STATE OF IOWA
DEPARTMENT OF COMMERCE
UTILITIES BOARD

IN RE: RAILROAD CROSSING SPECIFICATION EXHIBITS	DOCKET NO. 199 IAC 42.3(1)
---	----------------------------

ORDER APPROVING, WITH MODIFICATIONS, SPECIFICATION EXHIBITS

(Issued June 13, 2006)

IOWA OVERHEAD WIRELINE CROSSING

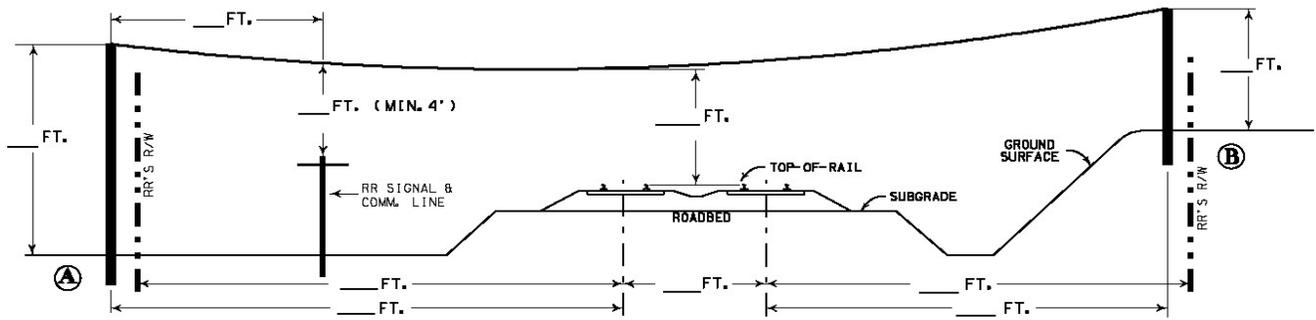
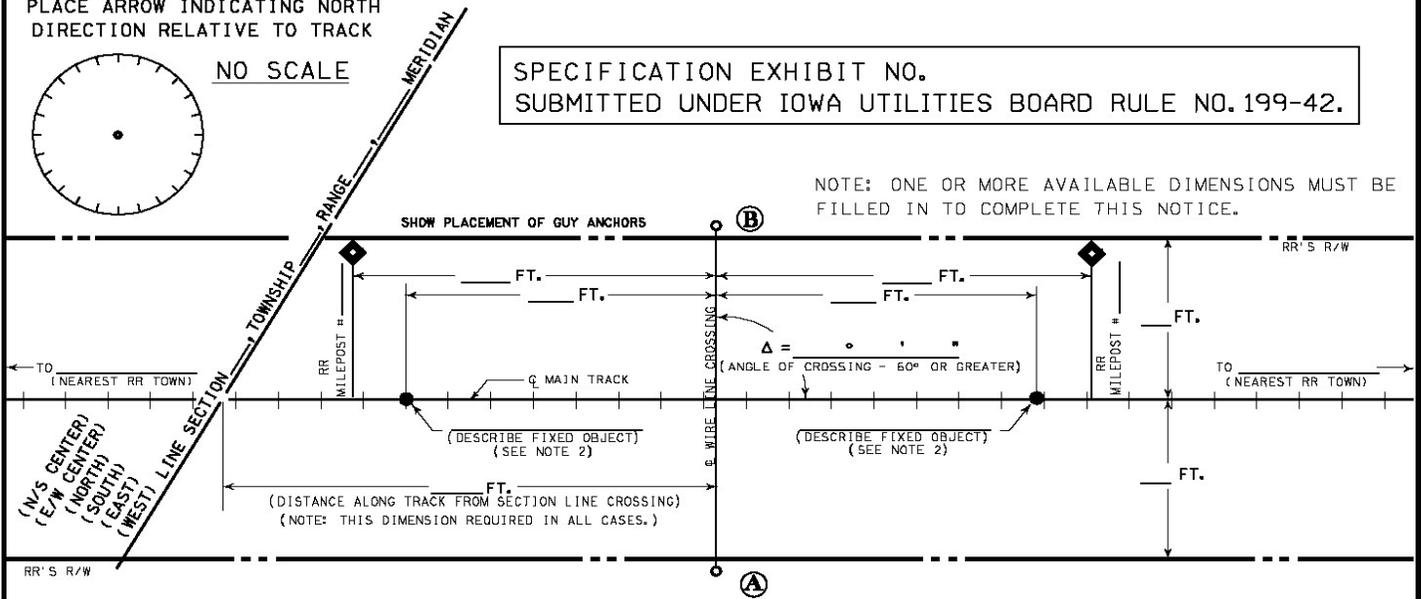
This proposed specification exhibit would apply to electric and communications overhead wires and cables. IPL and IAEC each objected to proposed Note M on the Iowa Railroad’s proposed exhibit. This note requests substantial information both on new substations to be built within a half mile of the track and on electric lines over 750 volts that are within 1,000 feet of the track for more than 500 feet. IPL said none of the Board’s rules require this information to be provided to railroads when electrical facilities are built near railroad tracks and there is no other similar state or national requirement. IAEC argued that utilities should not be required to provide information on facilities outside the railroad right-of-way; the scope of information should be limited to the crossing itself. The Iowa Railroad Group argued that the information is necessary to avoid potentially dangerous interference with railroad signals.

The Board does not find any support in statute or rule for the Iowa Railroad Group’s position and will delete Note M. Iowa Code § 476.27 and 199 IAC 42 address only railroad crossings, not substations or electric lines that are outside of

Guideline 1 to the proposed overhead wireline specification exhibit states measurements on a cross-section drawing of the crossing are to be taken at right angles to the track, even if because of an angled crossing the actual wire length is greater. One commenter, however, suggested that the Iowa Railroad Group actually intended to ask for the diagonal length. The Board proposes to adopt the guideline as drafted; if the Iowa Railroad Group intended to mean diagonal length, it can propose an amendment to the guideline.

Guideline 3 states construction will be in compliance with 199 IAC 42.7. The ITA pointed out that the referenced rule applies to pipelines and that 199 IAC 42.6 is

Subparagraph 199 IAC 42.6(2)"c"(2) requires poles be 50 feet from a straight railroad track, but allows them to be within 10 feet of an industry track. The Iowa Railroad Group, apparently concerned that the 10-foot rule could be used to place a pole too close to an adjacent straight track, included language in Guideline 6, Part 2, to prevent this. However, the language used by the Iowa Railroad Group would allow a pole to be placed less than 50 feet from the straight track if the pole were placed between the two sets of tracks.

Subparagraph 199 IAC 42.6(2)"c"(3) provides that "[t]owers for electric lines capable of operating at 34,500 volts or more shall not be located on railroad right-of-way." The term "tower" is not defined. Guideline 6, Part 3, proposed barring "multi-pole or lattice structured towers, or their equivalent, if other structures are used. . . ." from railroad right-of-way (emphasis added). The underlined language is a new proposal that did not appear on earlier versions of the guidelines that were informally

The issue here goes beyond the definition of a tower. The Iowa Railroad Group apparently would apply the rule and proposed guideline to block construction of a transmission line through a rail yard. The Board, through its franchise process under Iowa Code chapter 478, regulates the routing of electric transmission lines. Railroads possibly affected by such a proposed routing receive mailed notice of franchise petitions under 199 IAC 11.5(4) and have an opportunity to participate in the franchise proceeding. The merits of a transmission line route that crosses a railway in a particular manner, or a rail yard, are best addressed through the franchise process. If placement of a structure at such a location is necessary, mono-poles may be the best and smallest footprint option. The Board does not support an interpretation of the tower rule that would restrict the Board's routing authority and will delete the phrase "or their equivalent, if other structures are used" from the guideline.

Proposed Guideline 10 recommends that railroads be contacted in advance to determine the location of fiber optic cable and railroad signals. The guideline further

the correct reference. The Board agrees and will change the rule reference in the final form.

The ITA proposed alternate language, which the Iowa Railroad Group accepted with one change. The new provision proposed by the Iowa Railroad Group for Guideline 6, Part 2, is: "2) 50 feet near straight tracks, except for industry tracks where 10 feet is permitted provided there remains 50 feet from the center line of main line tracks." The Board believes this language is consistent with the rules and responsive to the concerns raised by the Iowa Railroad Group. The Board will include the new language in the final form.

3. Installation shall be in accordance with Iowa Utilities Board Rule 199 IAC 42.6.
4. In determining the minimum above top-of-rail clearance, the height of a rail car shall be assumed to be 23 feet instead of the 20 feet presumed for most applications by the American National Standards Institute (ANSI) C-2, the National Electrical Safety Code (NESC).

- 2) 50 feet near straight tracks, except for industry track where 10 feet is permitted provided there remains 50 feet from the center line of main line tracks. If located adjacent to curved track, the clearance shall be increased by 1.5 inches per degree of track curvature, and

- 3) multi-pole or lattice structured towers, if other structures are used, for electric lines capable of operating 34,500 volts or more shall not be located on railroad right of way.

IOWA UNDERGROUND WIRELINE CROSSING

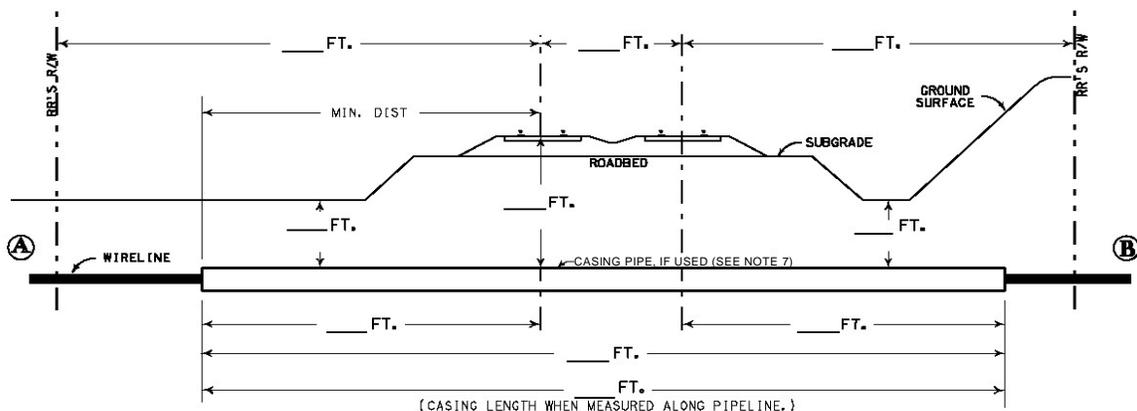
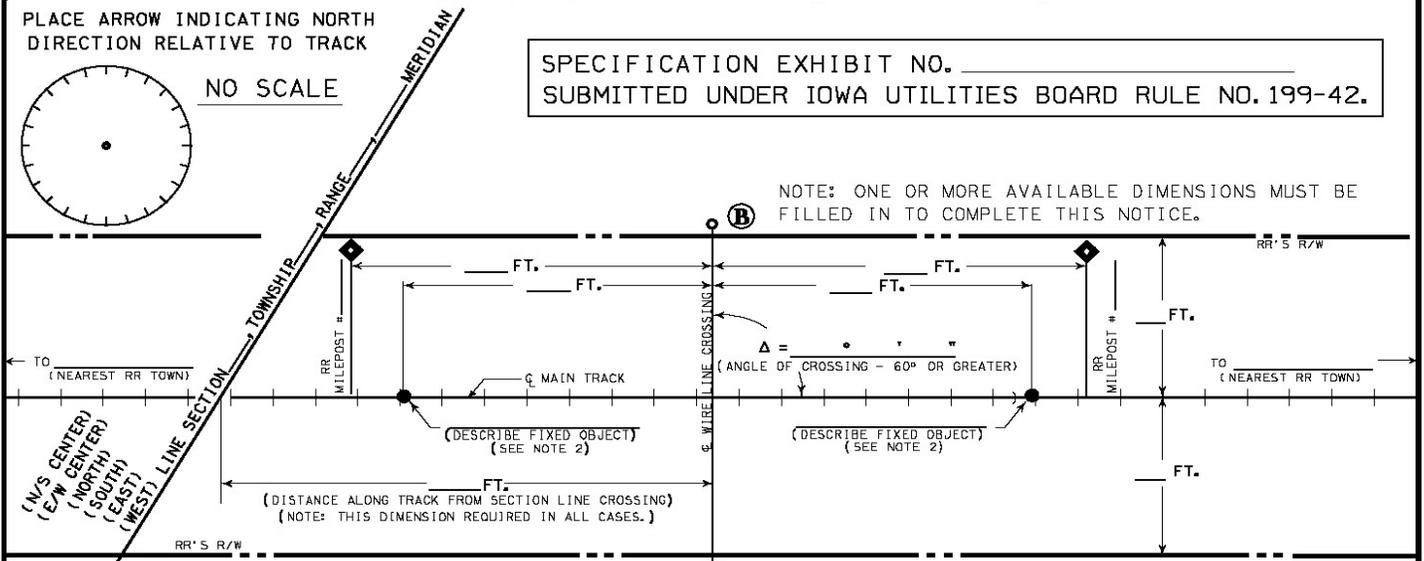
This proposed specification exhibit would apply to electric and communications lines crossing railroad right-of-way underneath the railroad. The proposed exhibit submitted by the Iowa Railroad Group presumes the wires or cables will be installed inside a casing. The Iowa Railroad Group argued that the language of the Board's rule (199 IAC 42.6) "speaks for itself" and requires casings. The Iowa Railroad Group also included extensive argument on why it believes casings should be required as a matter of good construction practice. The ITA responded that the Board's rules do not require casings; that the Board's engineering standards for electric and communications facilities (199 IAC Chapter 25), which are incorporated into the railroad crossing rules in 199 IAC 42.6(1), do not require casings; and that the Iowa Railroad Group's arguments regarding electrical hazards or signal

The Board rule that specifically addresses wireline crossings of railroads, 199 IAC 42.6, “[e]ngineering standards for electric and communications lines,” contains only one reference to casings, which is in subrule 42.6(3)"d." This subrule provides:

d. Casings must extend at least 30 feet from the centerline of the nearest track, measured at a right angle, except that casings for electrical conductors operating at more than 750 volts shall extend the full width of the right-of-way. At burial depths of less than 15 feet below the track, the casing material shall be steel or rigid metal conduit. At depths of 15 feet or more, polyvinyl chloride (PVC) casing pipe may be used.

The Iowa Railroad Group contended that the inclusion of this subrule means casings are required, while the ITA argued that this subrule only describes how casings are to be installed but does not require they be installed.

Whether pipelines should be encased was a disputed issue in the rule making proceeding that resulted in these rules, Docket No. RMU-02-7. The Board specifically required casings for one particular type of pipeline crossing (paragraph 42.7(1)"d" regarding slip jointed water and wastewater pipe), but not for all crossings. With that exception, the Board did not specifically require casings and the technical standards incorporated by reference in the rules do not require casings. The inclusion of standards for casings, if used, does not mandate their use. The Board will modify the proposed specification exhibit to require casing information only if the crossing will be encased.

Note F requires that the method that will be used to install the casing be identified. Consistent with the discussion above, Note F will be revised to apply whether the crossing is cased or uncased. The form currently provides the following options: Dry bore and jack; Tunnel; or Other. IPL and the WUA proposed that horizontal directional drilling (HDD) be added to the list of options. The Iowa Railroad Group responded that it would accept a reference to “dry bore horizontal directional drilling” if the utility is required to provide detailed information on its drilling methodology.

In Docket No. RMU-02-7, the Board adopted rules that specifically permit HDD techniques that use drilling mud. The mud is a semi-liquid bentonite (a type of clay) slurry. It appears adding “dry bore” to HDD could be construed as not allowing this commonly used and well-established installation method. Because the Board believes HDD will be a common method of utility installation, it should be listed as an option on the form; however, the Board will not add any qualifiers or special requirements for HDD’s use.

As with the overhead wire crossing specification form, the underground form’s guidelines have references to measurements being taken at right angles (Guideline 1), a rule reference to 199 IAC 42.7 instead of 199 IAC 42.6 (Guideline 3), contact information regarding fiber optic cable and railroad signal locations (Guideline 13), and information regarding electric lines and substations away from the crossing (Guideline 15). The Board will treat these issues for the underground guidelines in the same way it did for the overhead guidelines.

1. Horizontal distances, in cross section AB on the Specification Exhibit, to be measured at right angles from centerline of track, except as noted.
2. Allowable fixed objects include: back walls of bridges, centerline of road crossings and overhead viaducts (give road name), or centerline of culverts.

3. Installation shall be in accordance with Iowa Utilities Board Rule 199 IAC 42.6.
4. The minimum depth below the base of the rail shall be 4.5 feet, except for fiber optic cables, which shall be 5.0 feet.

6. Crossing shall not be installed within 50 feet of the end of a railroad bridge, the centerline of a culvert, or a switch area.
7. Casings, if used, must extend a minimum of 30 feet from the centerline of nearest track, measured at right angles, except that casings for electrical conductors, if used, operating at more than 750 volts shall extend the full width of the right of way. At burial depths of less than 15 feet below the base of rails, the casing material shall be steel or rigid metal conduit. At depths of 15 feet or more, polyvinyl chloride (PVC) casing pipe may be used.

IOWA NONFLAMMABLE PIPELINE CROSSING

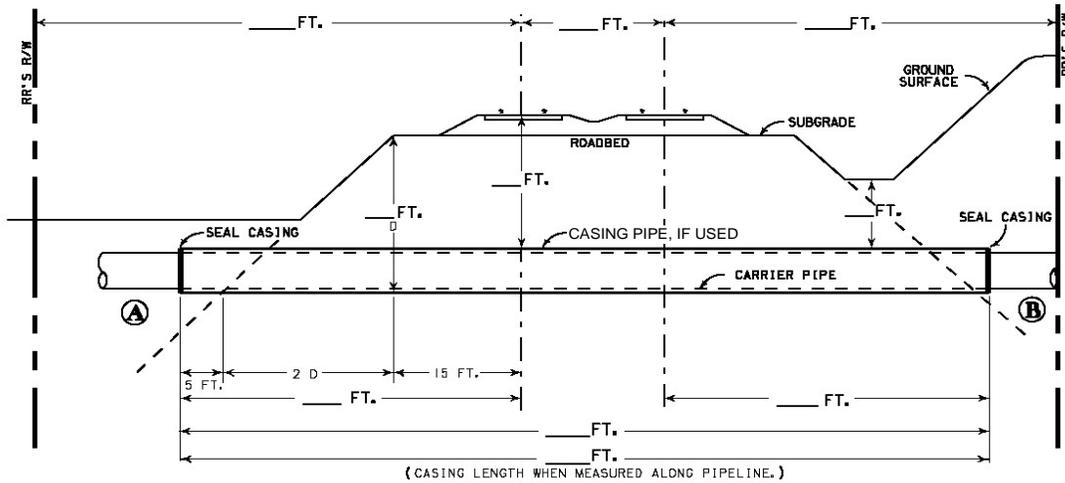
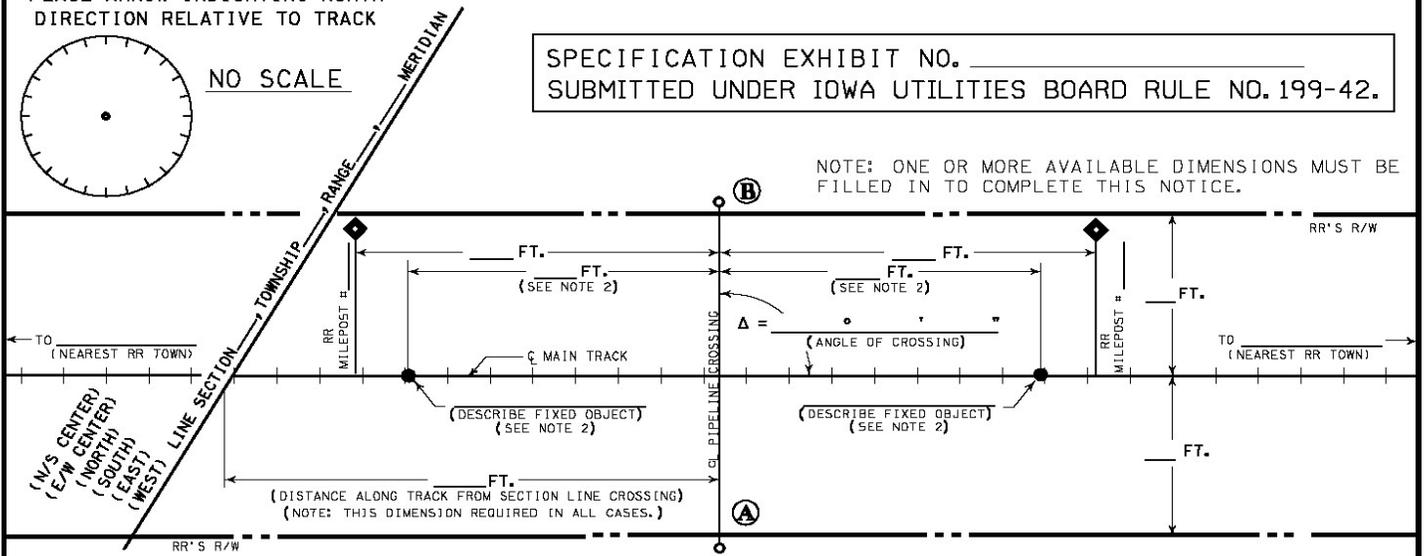
The proposed specification exhibit for encased nonflammable pipeline crossings would apply to pipelines carrying nonflammable substances, such as water and sewer lines. As was the case with underground wire crossings, some commenters indicated that the title of the specification exhibit appeared to require pipeline casings for all crossings. However, as noted earlier, the Board's rules require only that slip jointed water and sewer pipe must be encased.

Because casings are not mandatory except in limited circumstances, the proposed specification exhibit will be modified to require casing information only if the crossing will be encased. As was the case for underground wire crossings, the Board will consider future proposals to have separate specification exhibits.

Note E, which is the equivalent of Note F on the underground wireline form, will be revised to apply whether the crossing is cased or uncased. The Board also will adopt the same changes in language to accommodate HDD. This leaves the specification exhibit with three choices—dry bore and jack, tunnel, and HDD. Another category, "other", was proposed for deletion on the exhibit forms submitted by the Iowa Railroad Group. The Board will add "other" back to the form because the Board will not assume that the three options listed will be the only installation methods ever used.

Guideline 1 states measurements on a cross-section drawing are to be taken at right angles to the railroad track. However, at least one of the measurements

requested is not a right-angle measurement. The Board will add the phrase “except as noted” to this guideline. Guideline 7 relates to the same issues as Guideline 10 for overhead wireline crossings, that is, location of fiber optic cable and railroad signals. The Board will adopt the same solution here as it did for the overhead wireline crossings.

The language proposed by the Iowa Railroad Group for Guideline 10 is “[u]nless otherwise authorized by the Railroad, a Railroad representative must be present during the installation of pipeline crossings.” IPL proposed additional language stating that if the railroad is notified but the railroad representative is not present, the installation can proceed and the utility will not be charged for the cost of providing a representative. The WUA noted that the Board rules require the representative be present only if there are underground railroad signal lines in the area.

It is apparent from the two quotes that the Board intended to specifically prescribe when a railroad representative must be present. Neither the Iowa Railroad Group's language nor IPL's proposed amendment is consistent with the Board's rules. Since Board rules do not require a railroad representative be present at pipeline crossings except as provided in paragraph 42.7(2)"f," the Board will delete Guideline 10.

The WUA noted that PVC pipe is acceptable in Board rules for water and wastewater usage and requested that PVC pipe be added to the list of approved materials in the exhibit guidelines. However, the proposed specification exhibits provided by the Iowa Railroad Group do not include an approved material list. Because the Board's rules specifically allow PVC pipe to be used for water and wastewater pipelines (199 IAC 42.7(1)"c"), no change to the specification exhibit to specifically list PVC pipe is necessary.

1. Horizontal distances, in cross section AB on the Specification Exhibit, to be measured at right angles from centerline of track, except as noted.
2. Allowable fixed objects include: back walls of bridges, centerline of road crossings and overhead viaducts (give road name), or centerline of culverts.
3. Installation shall be in accordance with Iowa Utilities Board Rule 199 IAC 42.7.
4. Steel Casing Wall Thickness Chart:

IOWA FLAMMABLE PIPELINE CROSSING

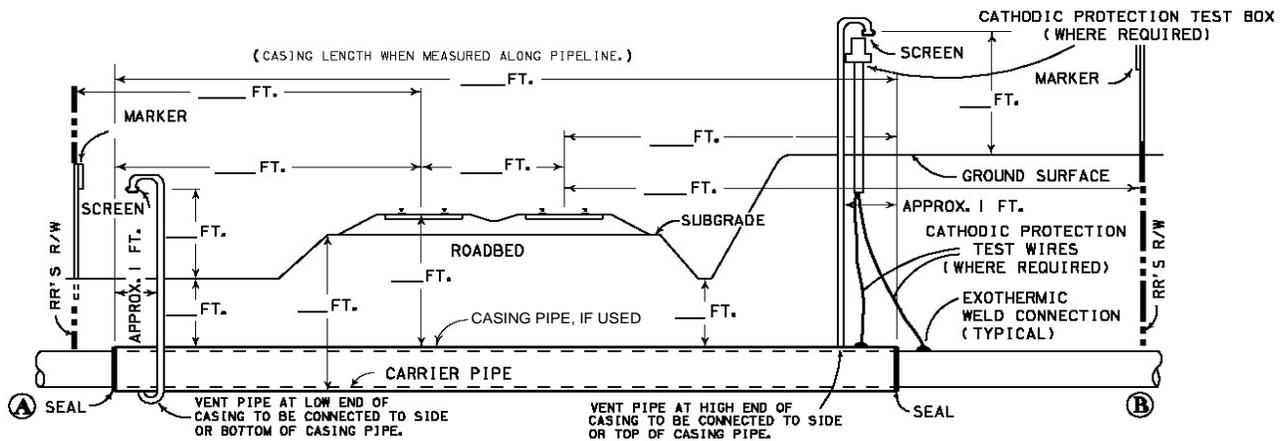
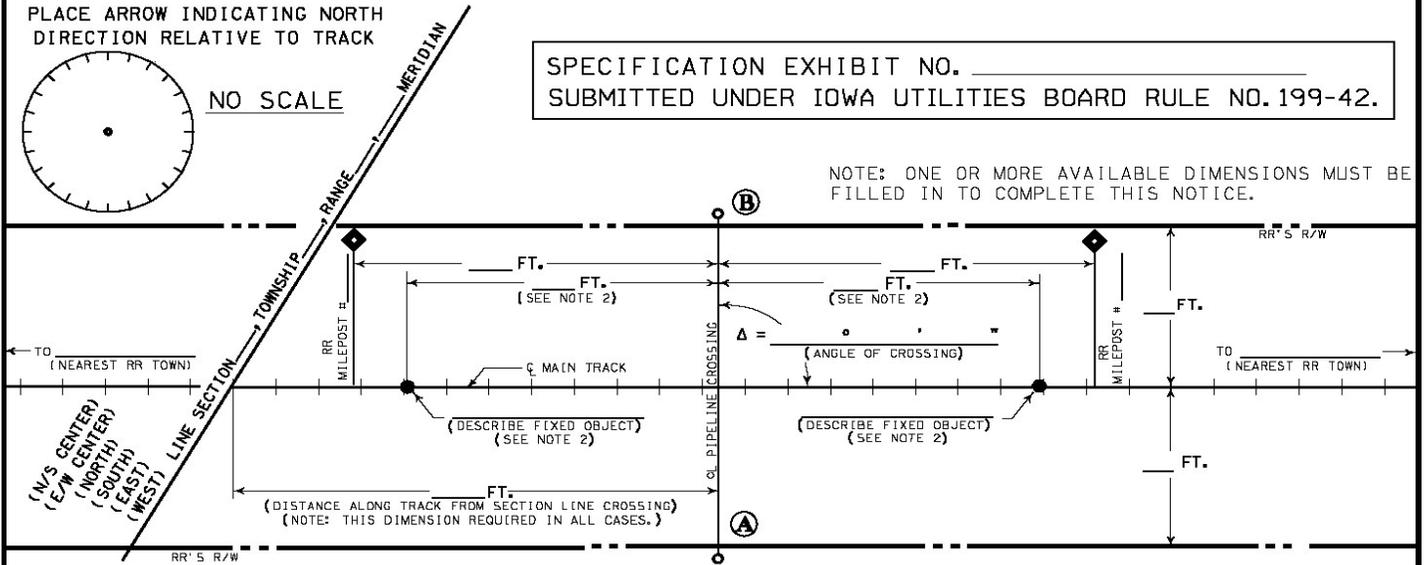
The proposed specification exhibit for encased flammable pipeline crossings would apply to pipelines carrying flammable substances, such as natural gas or petroleum products. The only difference between this proposed specification exhibit and the one for non-flammable pipelines is that the exhibit for flammable pipeline crossings presumes the casing will have vent pipes and therefore additional drawing detail is requested. The guidelines, although numbered a little differently, are identical in the two proposed exhibits, and the Board will adopt the same

modifications to the flammable pipeline crossings exhibit as it did to the nonflammable pipelines crossing exhibit.

1. Horizontal distances, in cross section AB on the Specification Exhibit, to be measured at right angles from centerline of track, except as noted.
2. Allowable fixed objects include: back walls of bridges, centerline of road crossings and overhead viaducts (give road name), or centerline of culverts.
3. Installation shall be in accordance with Iowa Utilities Board Rule 199 IAC 42.7.
4. Steel Casing Wall Thickness Chart:
